# CLOVERLEAF FILING 2

# STORM SEWER AND POND PLANS

AS-BUILTS  
05/24/2023  
SF-21-023

# V1\_As-Built Construction Drawing.pdf Markup Summary

- POND 4 OUTLET STRUCTURE NOTES:**
- ORIFICE PLATE:
    - PROVIDE CONTINUOUS NEOPRENE GASKET MATERIAL BETWEEN THE ORIFICE PLATE AND CONCRETE AND BETWEEN THE RESTRICTOR PLATE AND CONCRETE.

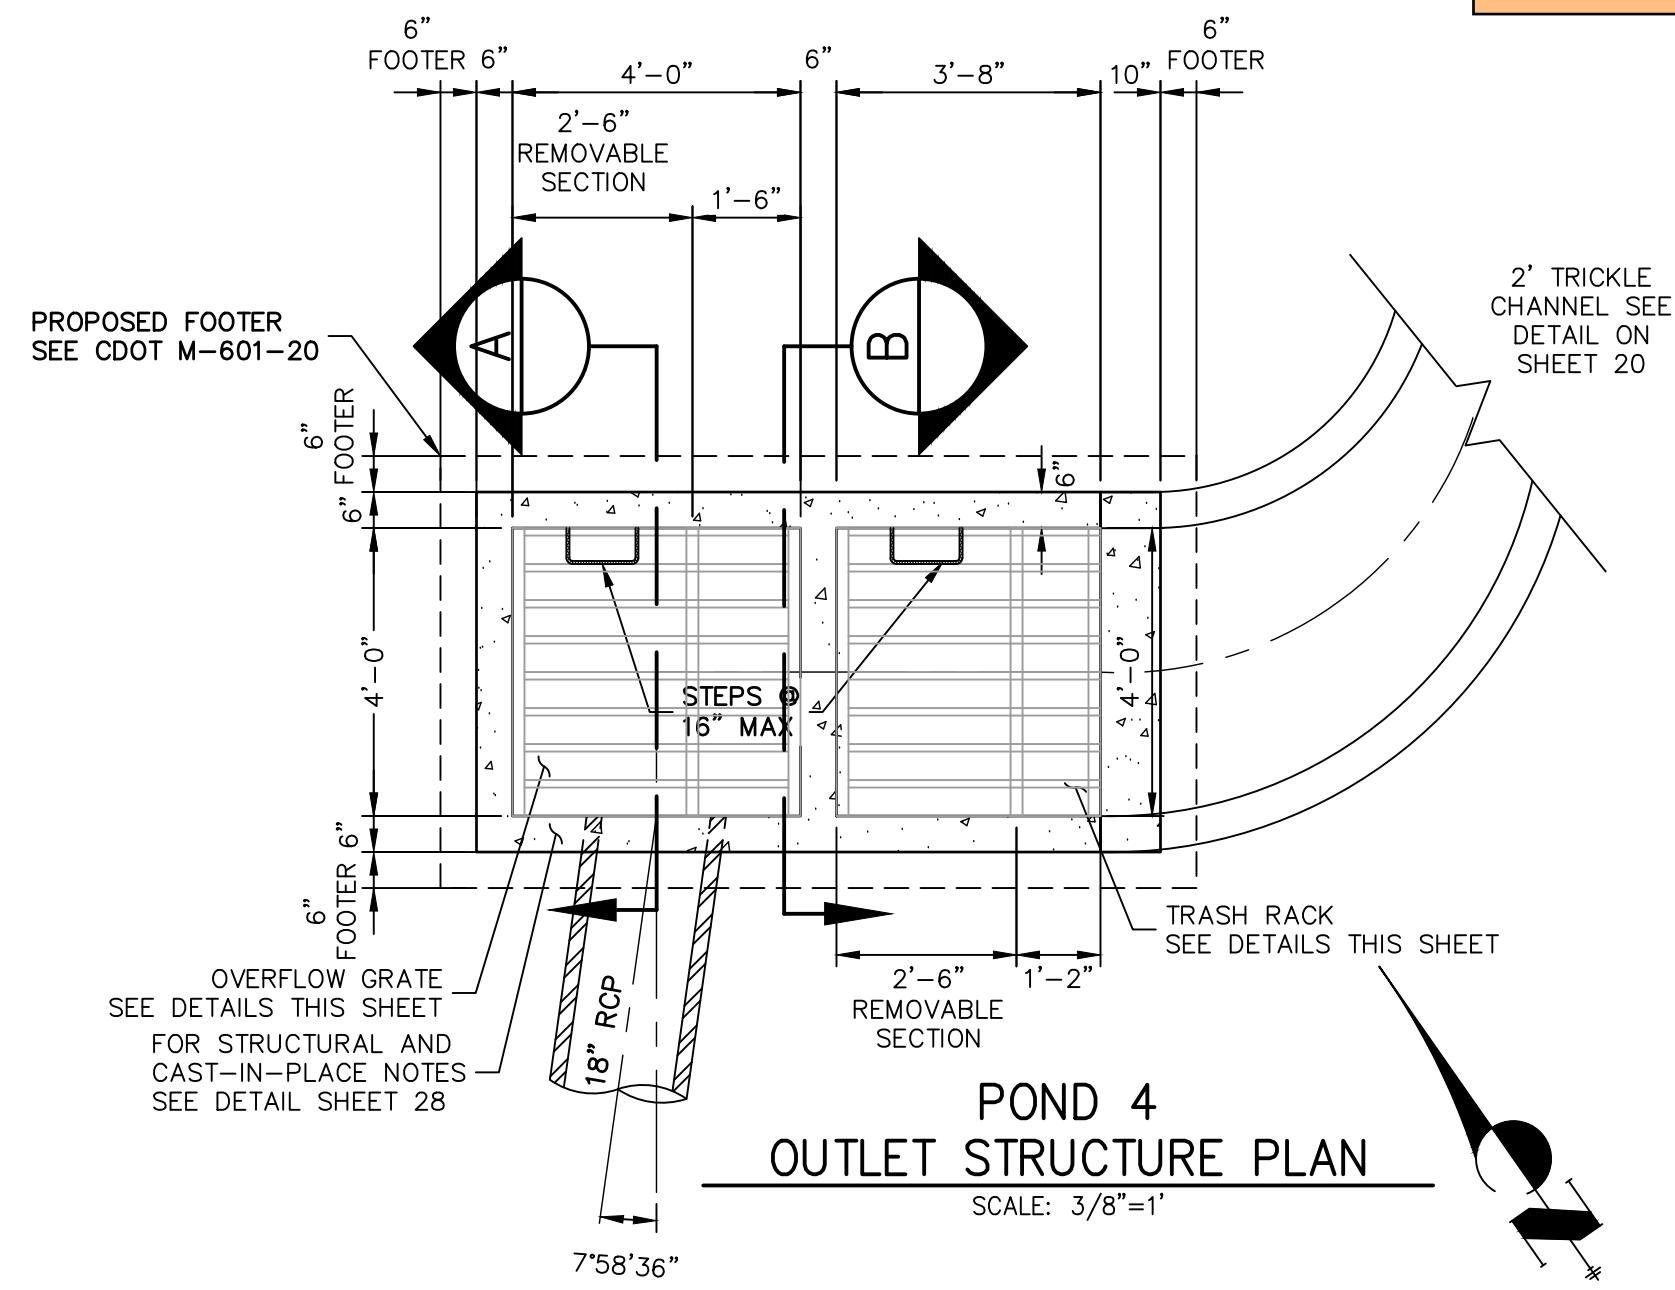
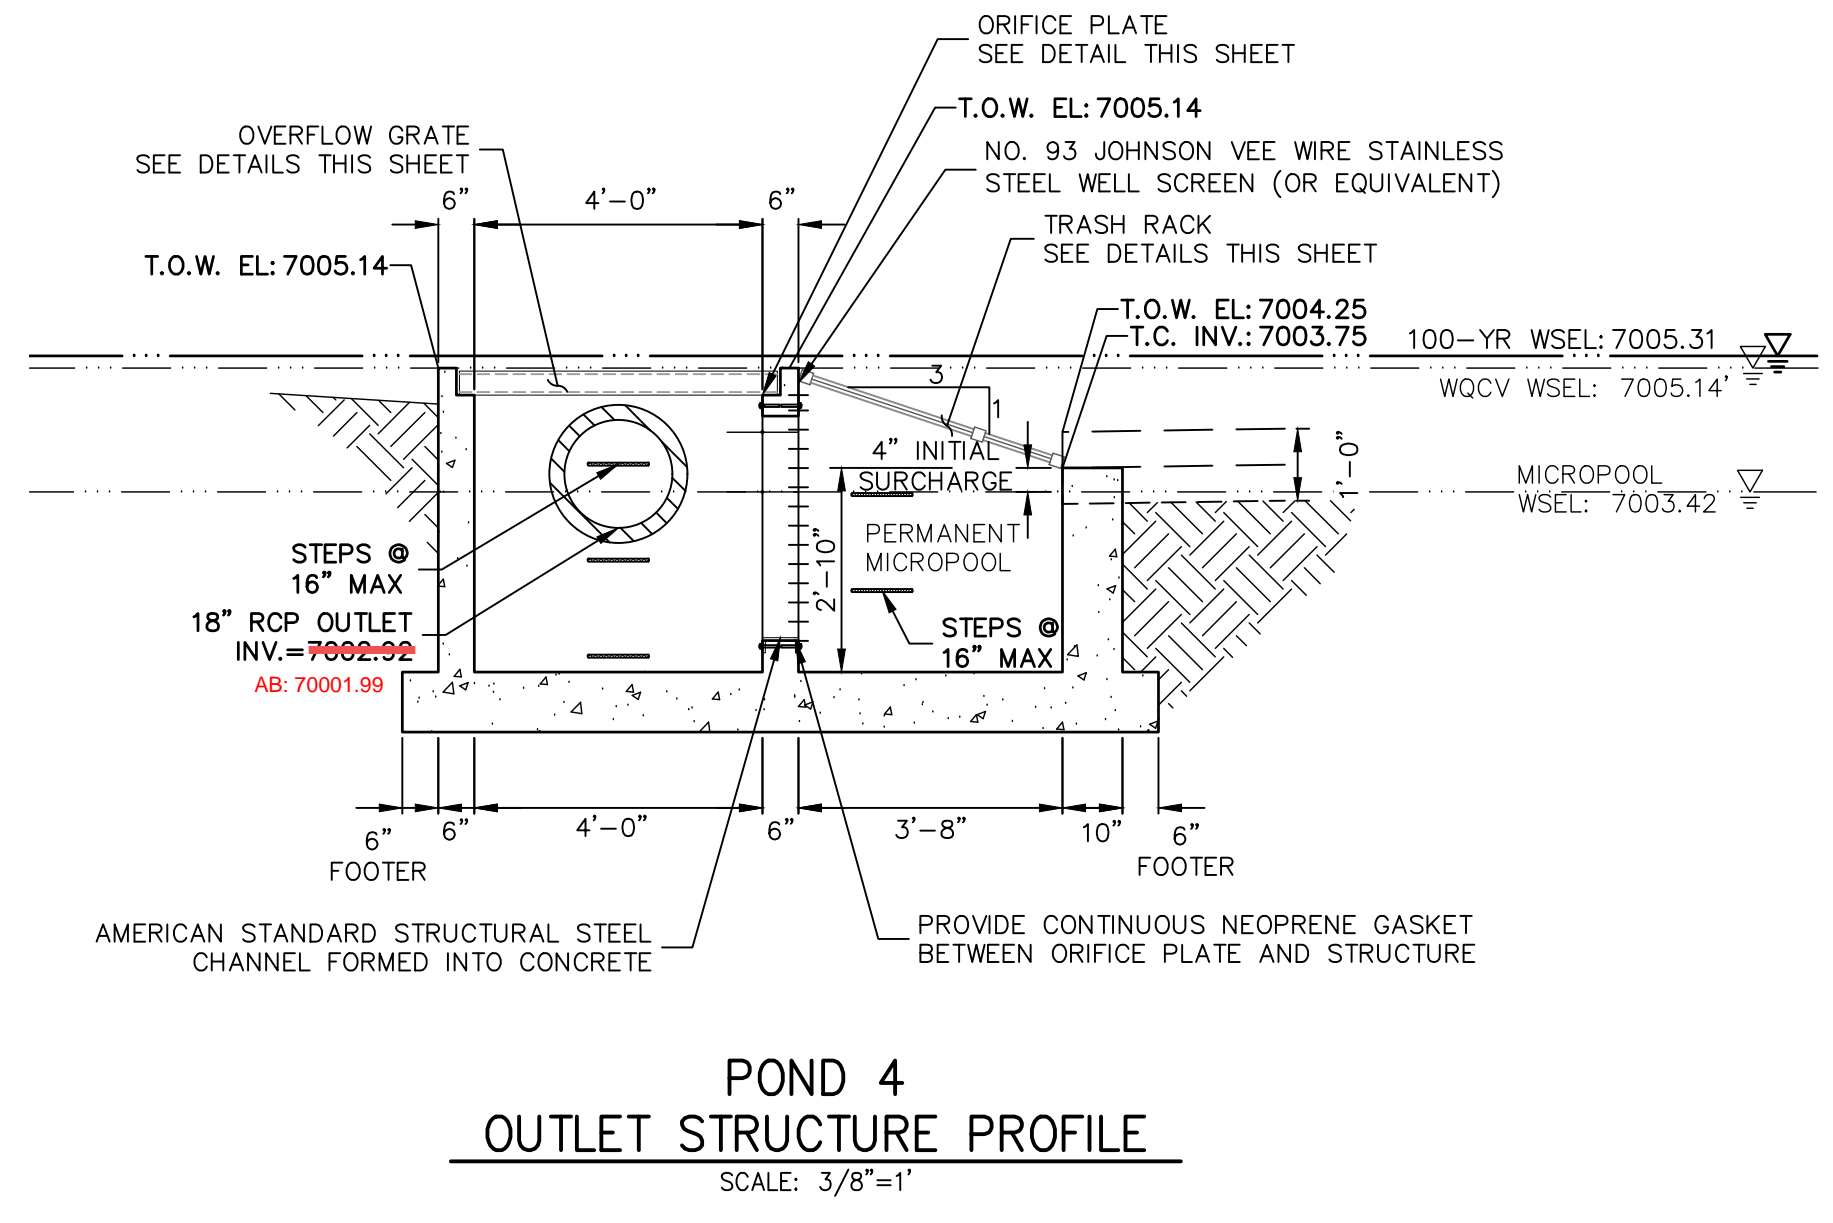
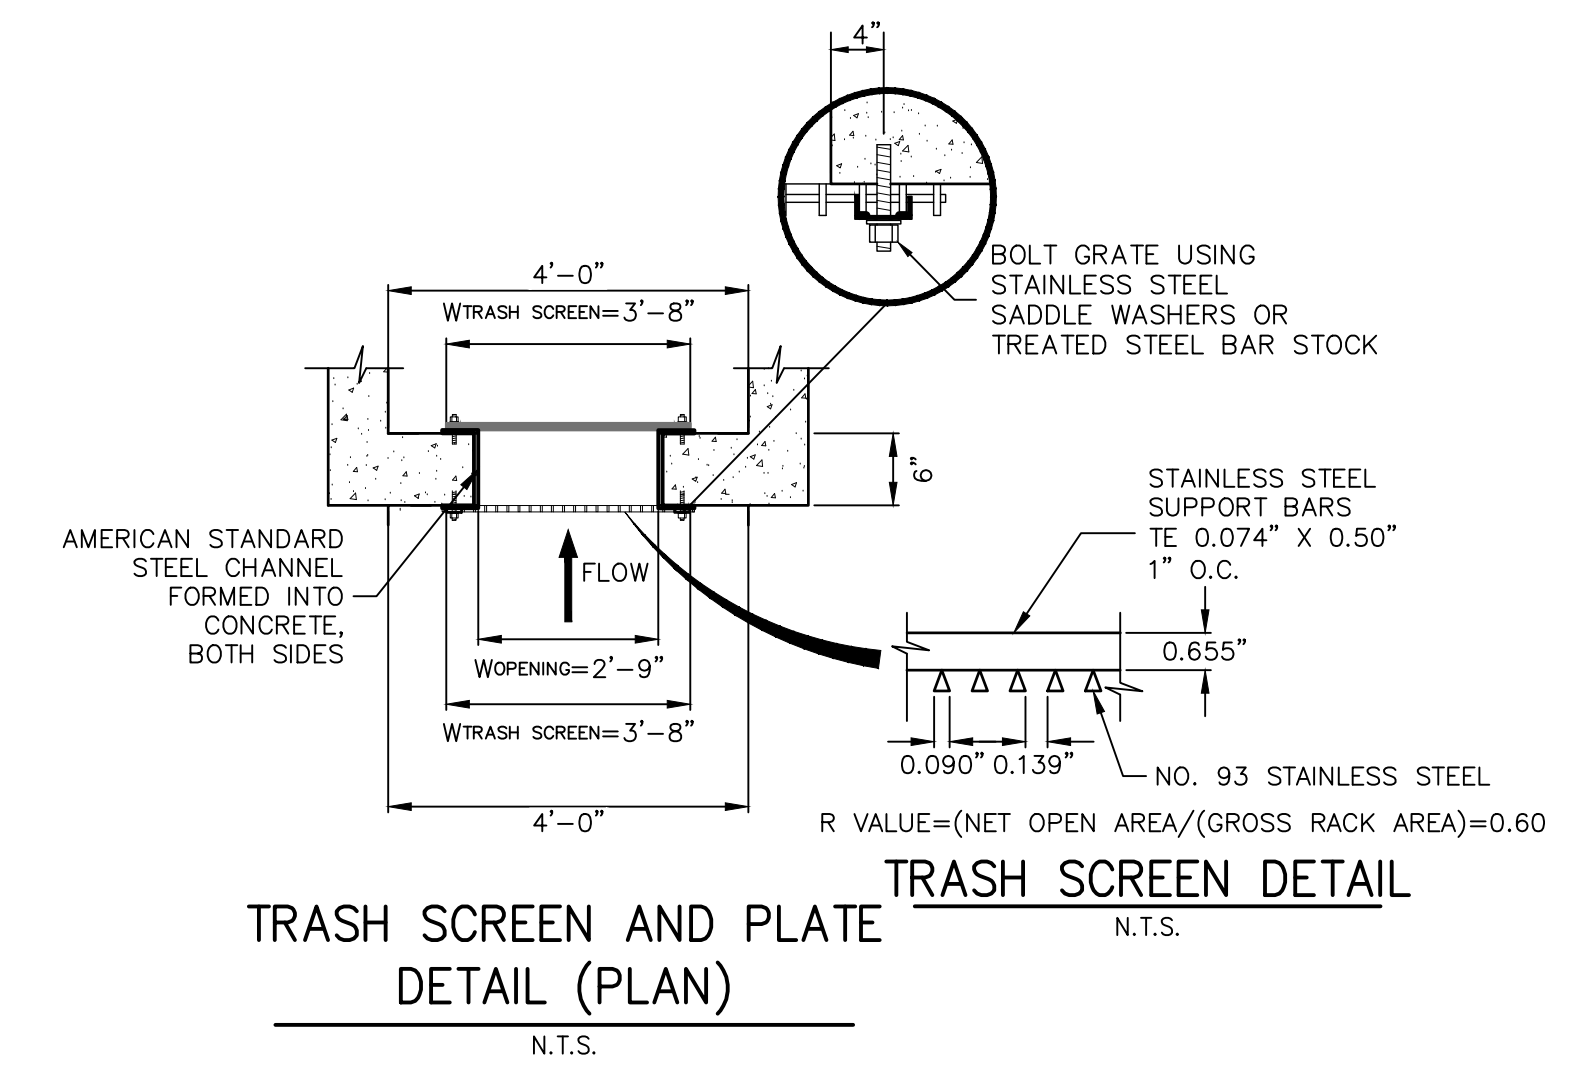
Need MHFD outlet structure calc to verify acceptability of the changes shown on this sheet

**DRAIN BASIN  
OUTLET FRONT DETAIL**  
SCALE: N.T.S.

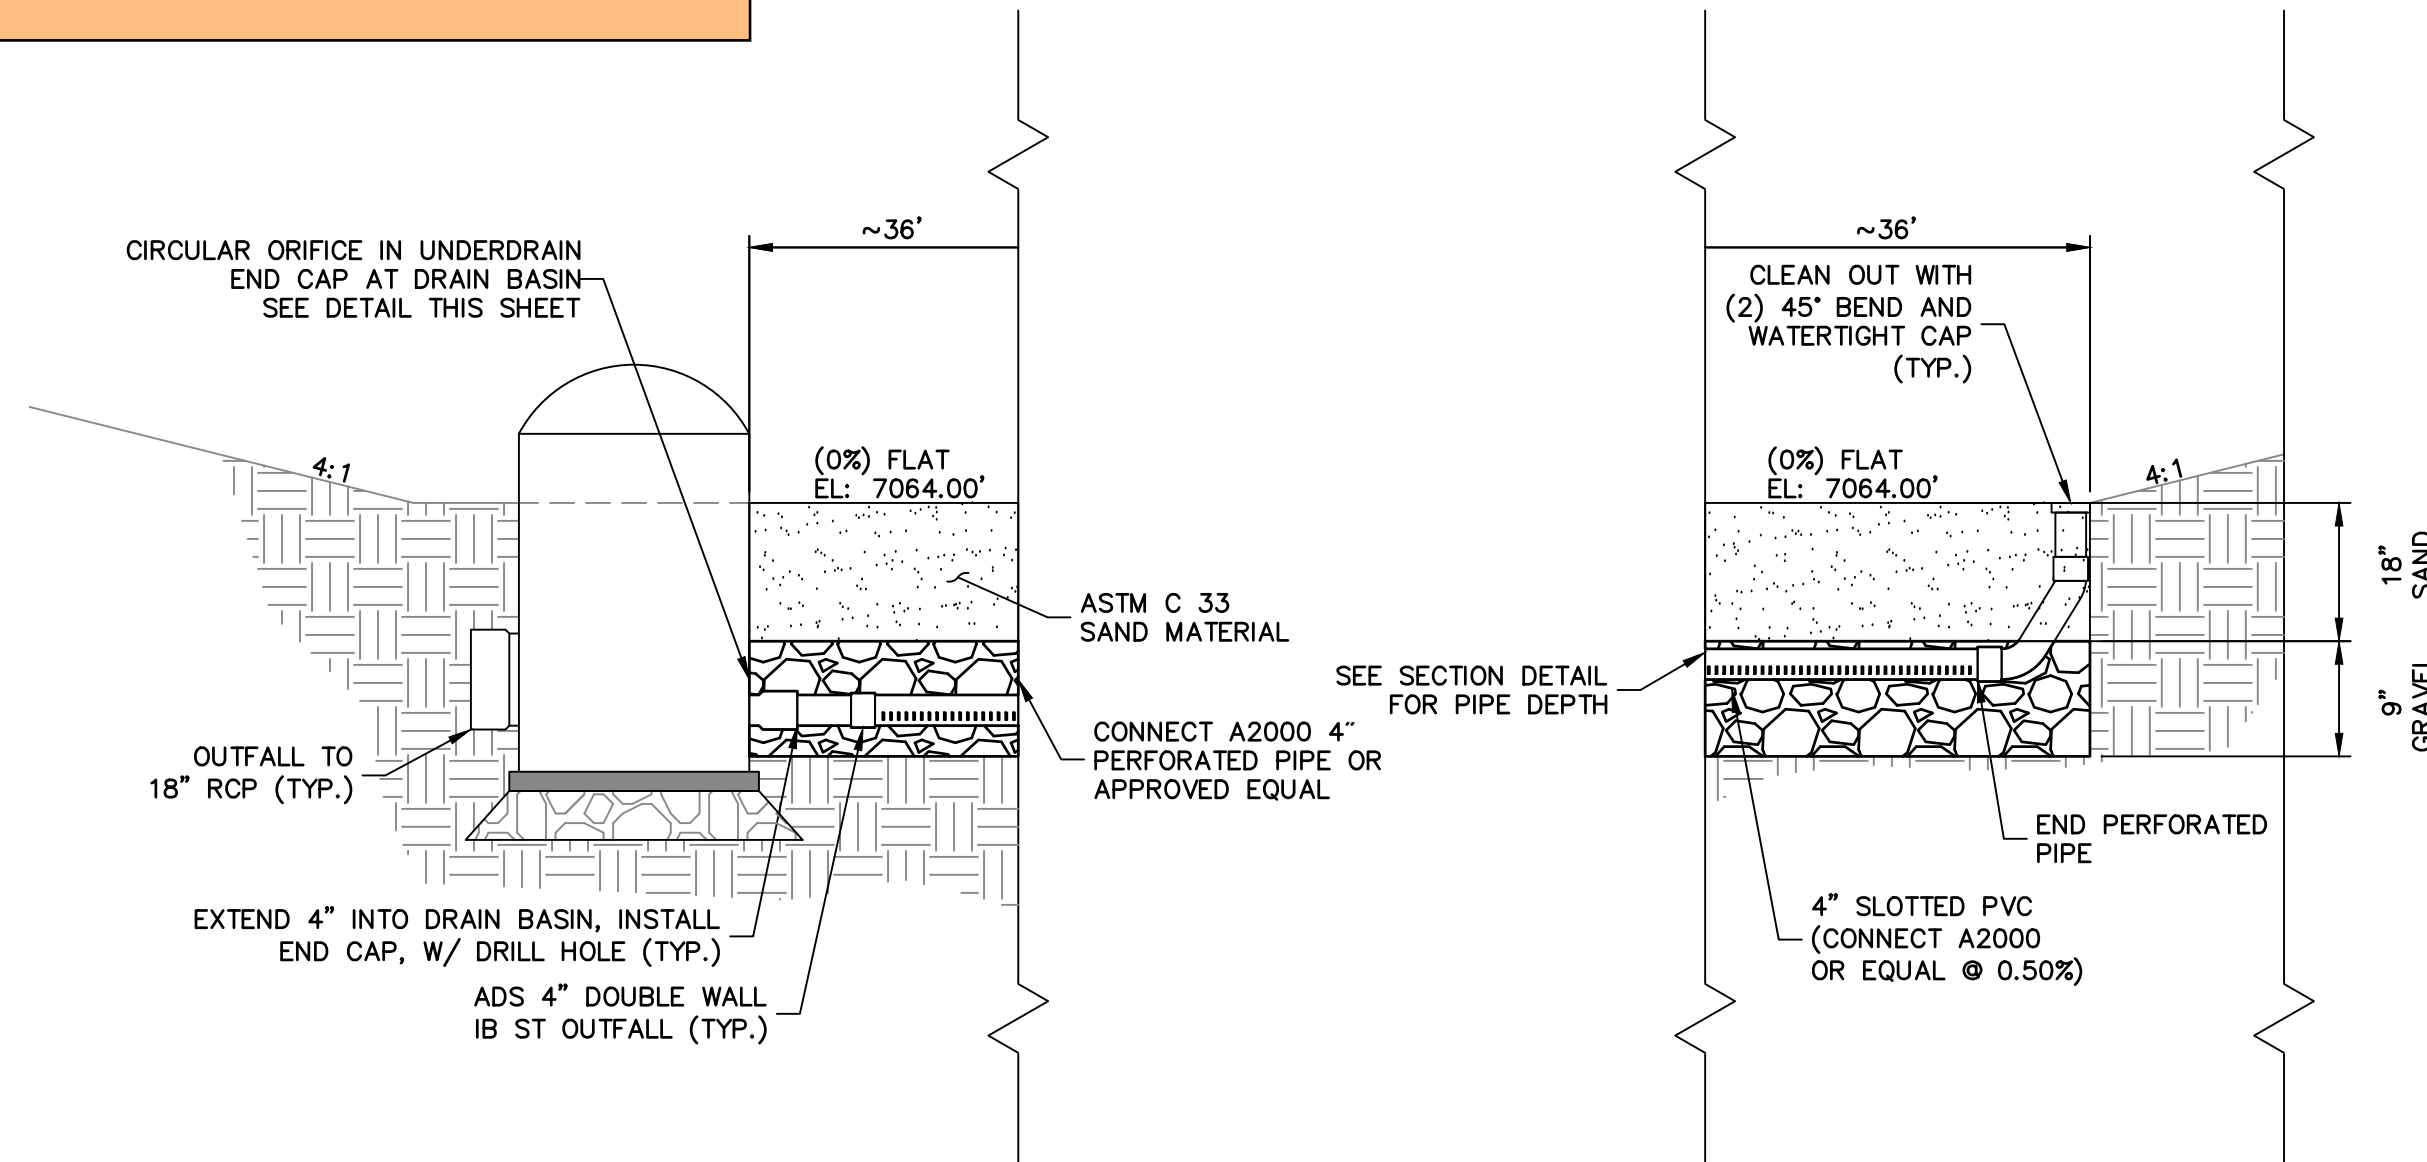
Comments on page two of the Stormwater PA Punchlist:  
 • Per "Drain Basin Outlet Front Detail" on Sheet 25 of 28, the outlet grate was supposed to be installed -9" from the base of the filter media. Instead it was installed flush with filter media. Regrade pond to meet design intent.  
 • Per "Sand Filter Underdrain End Cap Detail" on Sheet 25 of 28, the hole in the end cap was supposed to be installed close to the bottom. Instead it was installed turned 90 degrees from bottom (ie: on the side of the cap). Re-install per plan or address with updated as-built plans and calcs.

It does not appear that this basin was installed per plan. Install per plan or revise these as-builts to show installed condition.

The Drain Basin Outlet Front Detail on Sheet 25 of 28, the outlet grate was supposed to be installed ~9" from the base of the filter media. Instead it was installed flush with filter media. Regrade pond to meet design intent.

Per "Sand Filter Underdrain End Cap Detail" on Sheet 25 of 28, the hole in the end cap was supposed to be installed close to the bottom. Instead it was installed turned 90 degrees from bottom (ie: on the side of the cap). Re-install per plan or address with updated as-built plans and calcs.

SHEET 7 OF 20  
 JOB NO. 25158.01

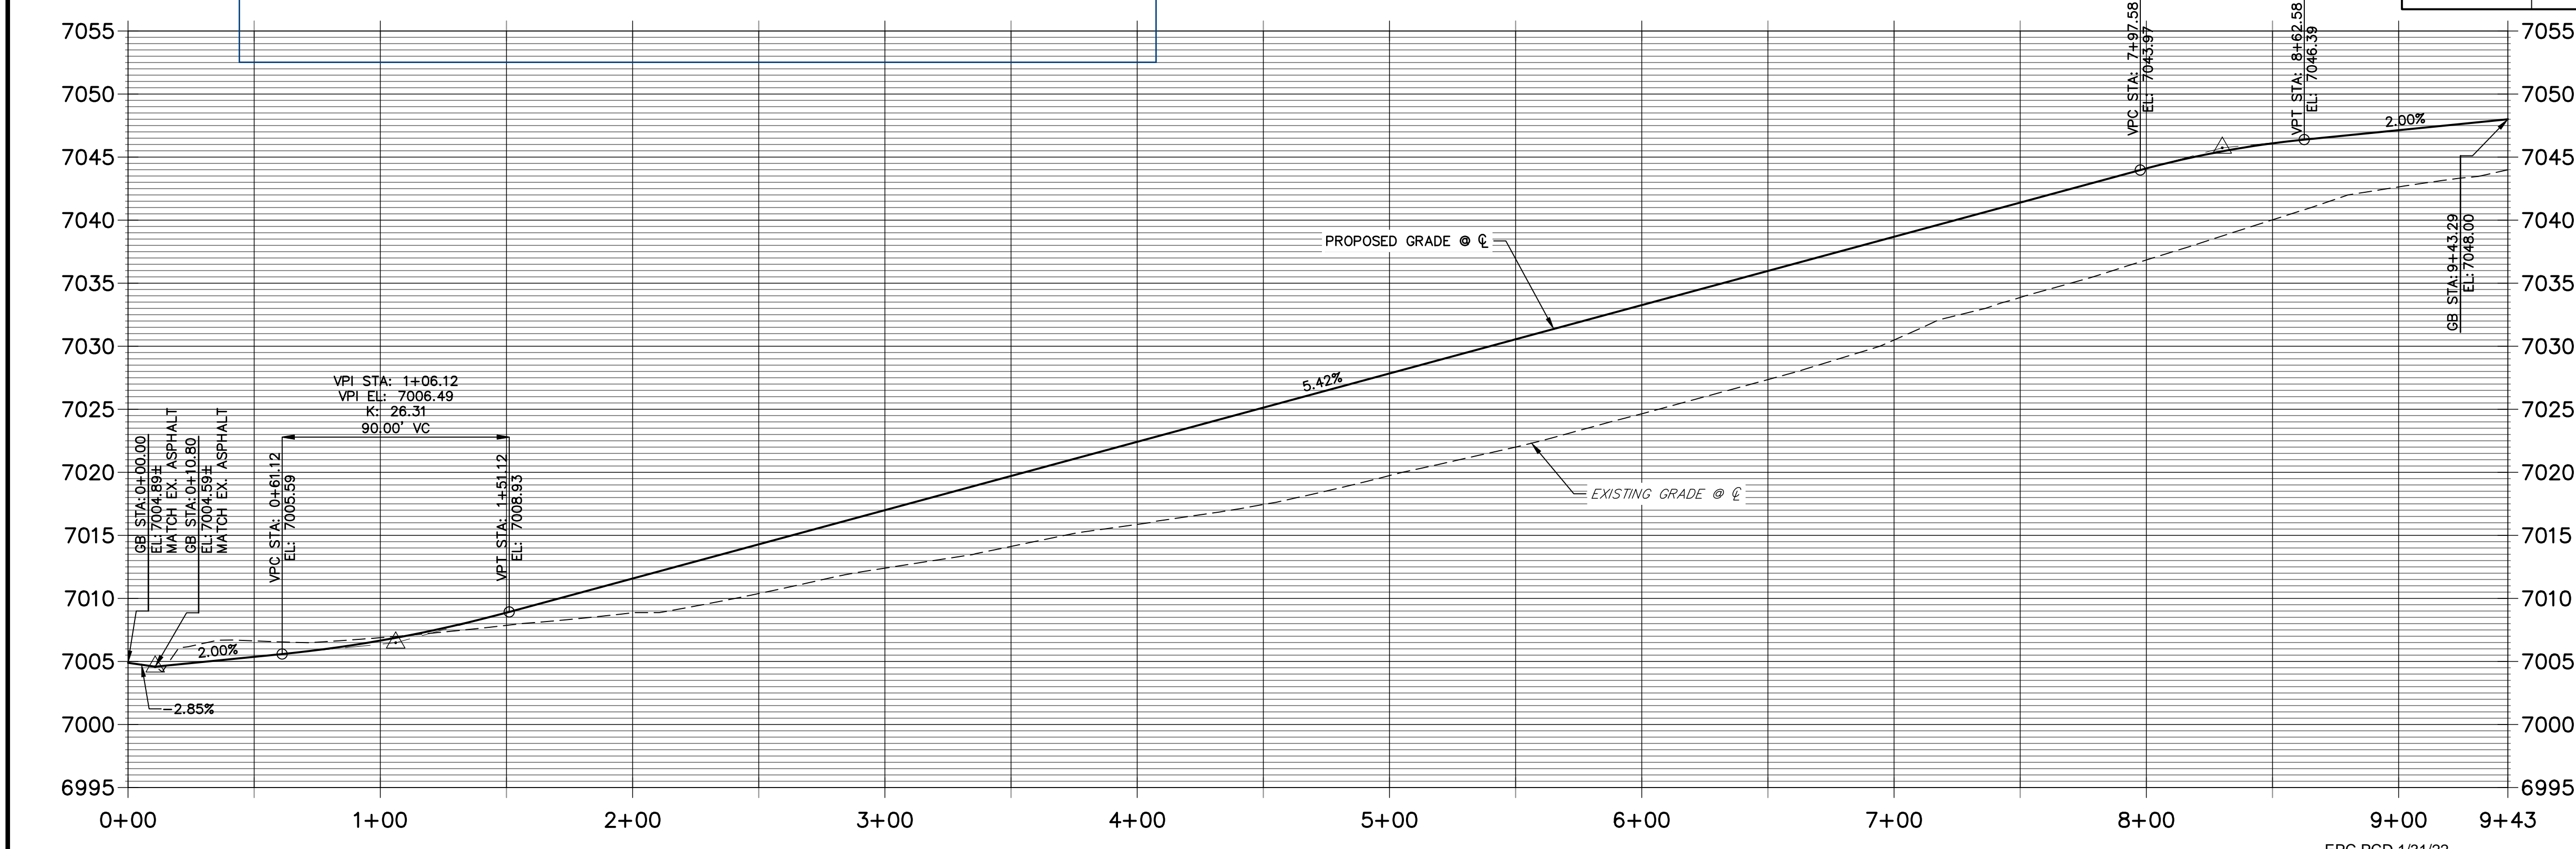
Show where the sidewalk goes around the inlets
